**Englobe File No.: 02105316.002**

**Regional Municipality of Niagara**

**Re:**              **Peer Review of – Air Quality Assessment, First Iteration Comments  
Upper's Quarry Walker Aggregates Inc.**

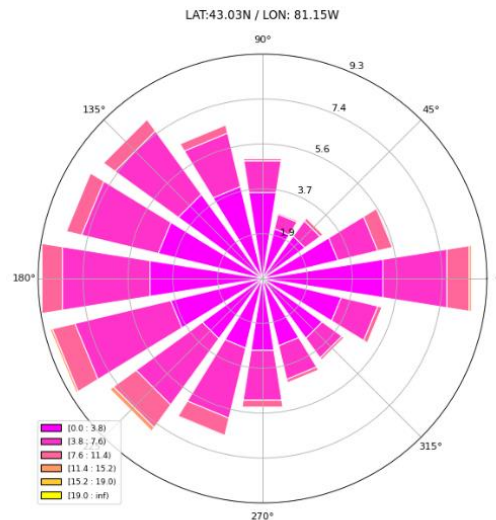
- The wind rose shown below indicates that the prevailing wind direction is mostly between the southwest and the northwest, but it has also a strong component from the east.
- Since AERMOD is not a terrain-following coordinate system code, how was it applied to a domain
